SITE: Land South of Church Road, Brampton Abbots, Ross-on-Wye, Herefordshire

DESCRIPTION: Construction of 7 no. residential dwellings with garages/ car ports

APPLICATION NO: 192312

DATE OF THIS RESPONSE: 10/10/2019

Figure 1: Environment Agency Flood Map for Planning (Rivers and Sea), Jan 2017

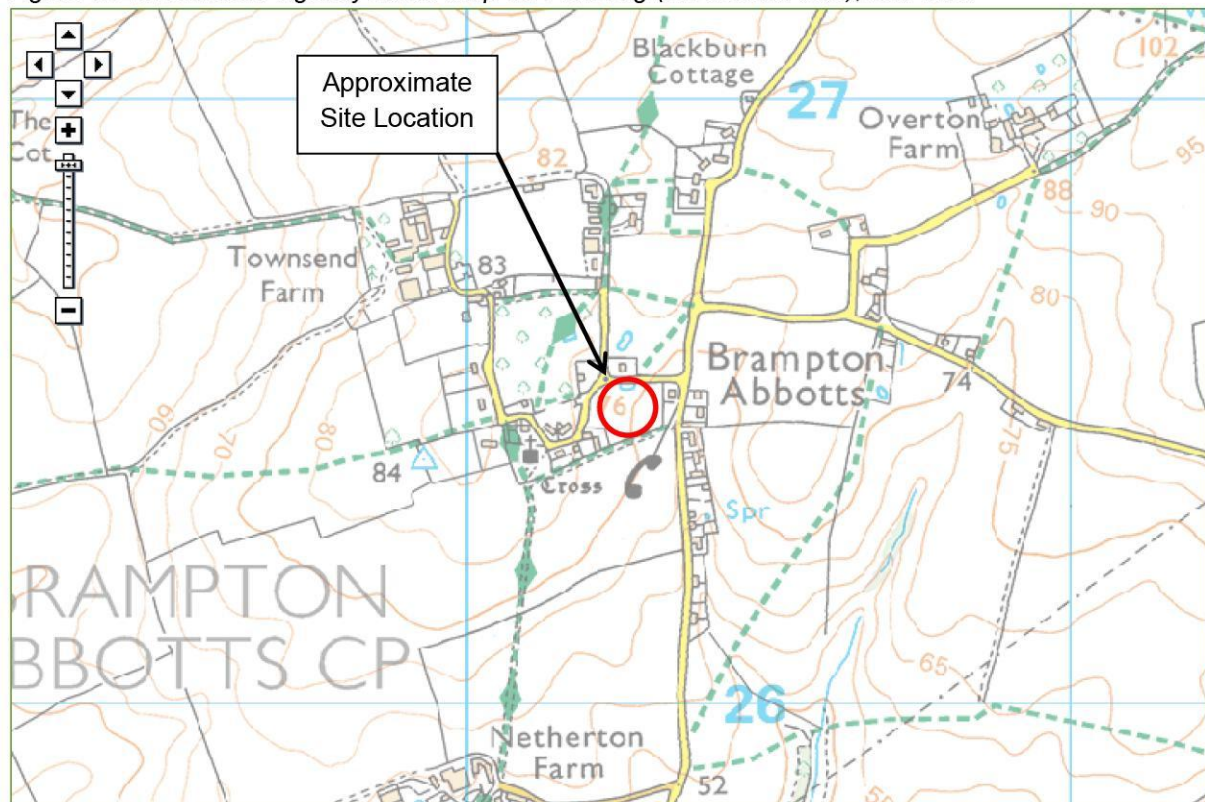
Review of the Environment Agency's Flood Map for Planning (Figure 1) indicates that the site is located within the low risk Flood Zone 1. Flood Zone 1 comprises land assessed as having less than a 1 in 1,000 annual probability of river flooding.
